08-358r1

Proposal for SAS 2.1 Specification to Enable Support for Active Cables

Revision 11

List of Proposed Modifications to SAS 2.0 to Enable Active Cables

Figure 98 — Mini SAS 4x active cable plug connector that attaches to an enclosure out port

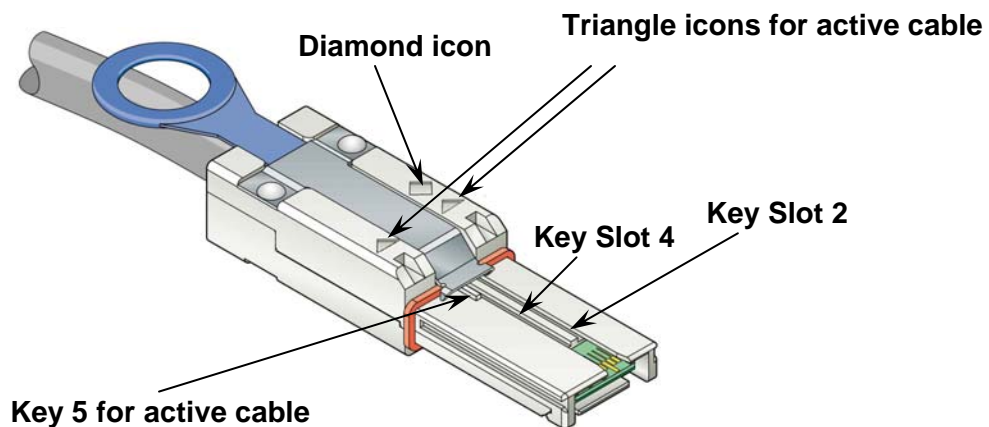
- *Added details of new keying scheme incorporating blocking key in position 5 on the plug and key slots 3 and 5 on receptacle. Updated Figure 98, Table 58 and Table 59 accordingly, added figures 99-101.*
- *Changed the wording in second paragraph of 5.2.7.2.2.1 and second paragraph of 5.2.7.2.2.2 to describe the keying scheme.*
- *Changed the wording of 5.2.7.3.4 from
“The active cable power supply shall have protection against the connection of the Vcc pin to ground or over-current loading, and shall limit the output current when the supply voltage drops below 2.3 V.”
to
“The active cable power supply shall have protection against the connection of the Vcc pin to ground or over-current loading.”*

- *Changed details of active plug keying scheme to differentiate between plugs attaching to enclosure in and enclosure out ports. Updated Figure 98, Table 58 and Table 59 accordingly, added Figure 99, renumbered subsequent figures to be 100-102.*

In order to ensure that active cables are not intermateable with passive receptacles, differentiating keying shall be provided by having key slots in positions 2, 4 and 6 and a blocking key in position 5 on the plug connector, and key slots in positions 3 and 5 on the receptacle connector in addition to keys 2, 4 or 6 used identify a receptacle for an enclosure out, in or universal port. In addition, two triangle icons on each side on the plug connector shall be added to the plug connector to identify an active cable assembly. The plug connector key positions and icons are summarized in Table 58.

Figure M.1 — Dual comparator design for active cable detection

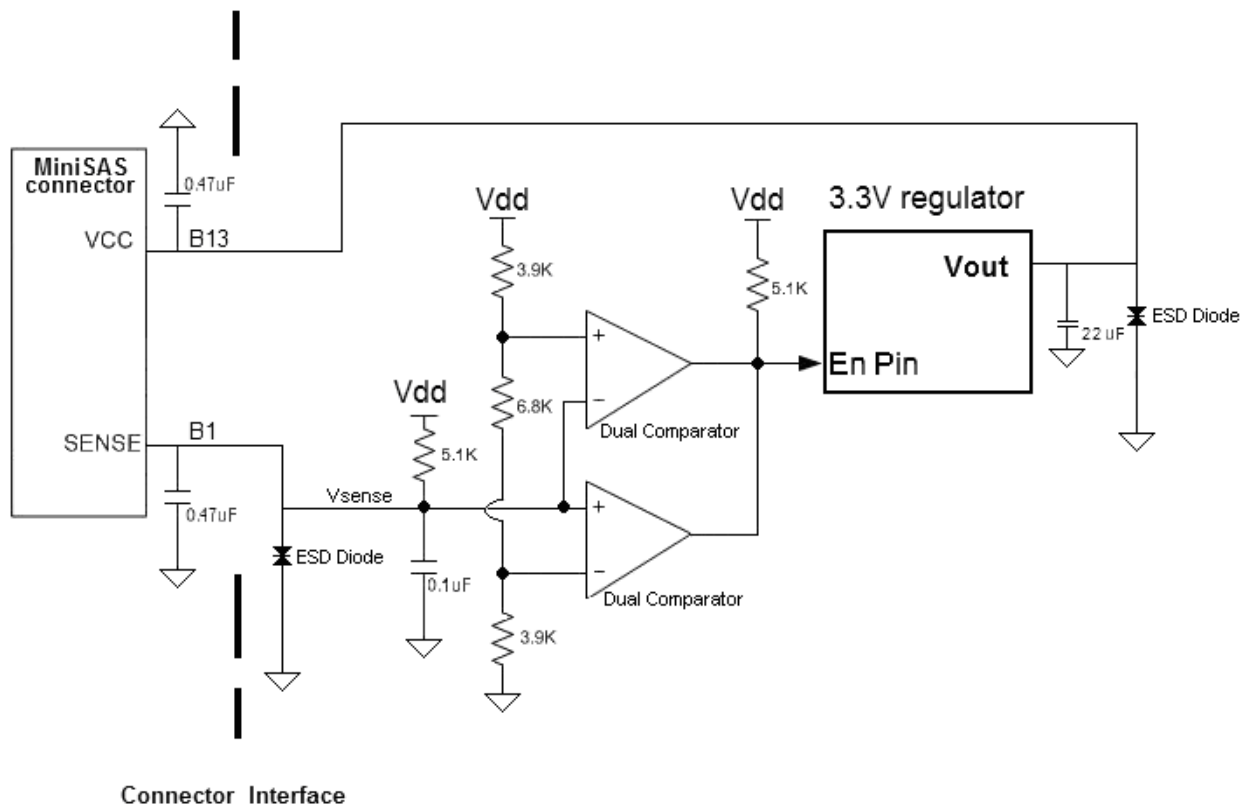
- *Edited most of the wording throughout the document to conform to the T10 style guide and to incorporate comments received from the group*
- *Deleted the minimum value for Supply Current in Table 61 and changed the maximum value from 600 mA to 319.4 mA.*
- *Edited the Informative Annex M to conform to the T10 style guide, dropped Table M.1 (parts List) and edited Figure M.1 to identify the function of the components.*

- *Title and other references to the specification is now 2.1 instead of 2.x*
- *The pinout of active mini SAS cables has been changed in Table 60: the Sense pin is now B1 instead of B10, and pin B10 reverts to ground. The change is also reflected in Figure M.1 of Annex M.*
